City of Portland, Maine – Building or Use Permit Application 389 Congress Street, 04101, Tel: (207) 874-8703, FAX: 874-8716

Proposed Project Description: construct 16' x 10' deck				PEDESTRIAN ACTIVITIES DISTRICT (P.A.D.) Action: Approved <input type="checkbox"/> Approved with Conditions: <input type="checkbox"/> Denied <input type="checkbox"/> Signature: _____ Date: _____			
Permit Taken By: Vicki Dover		Date Applied For: 8/25/97

RE: 24 Mayland Street

BUILDING PERMIT REPORT

MORTGAGE LOAN INSPECTION PLAN

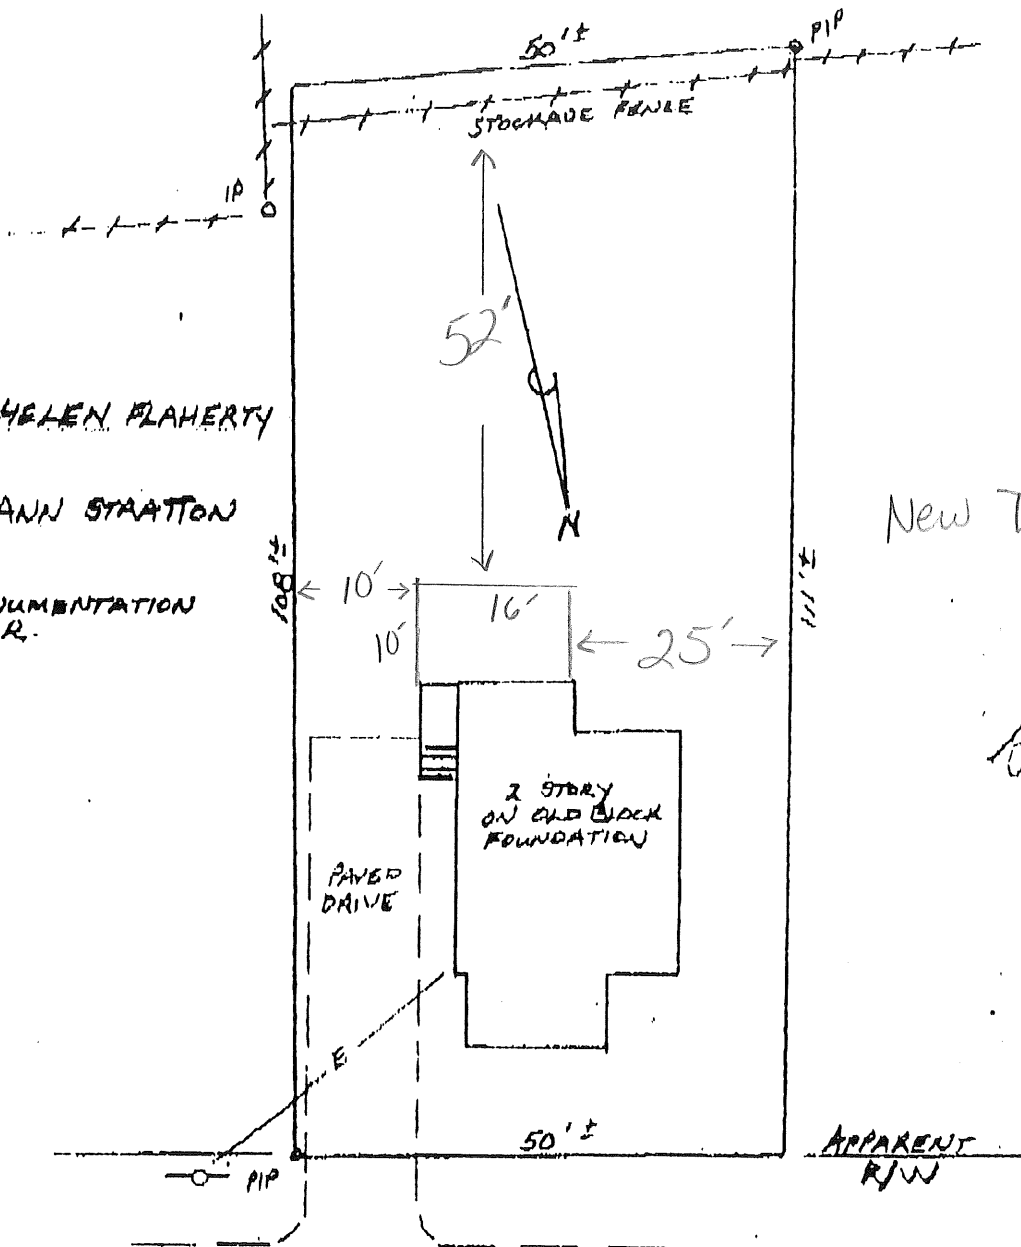
New Deck =
10' x 16'

Rear Yard - 20' req. - 52' shown

Side Yard - 8' req. - 10' & 25' shown
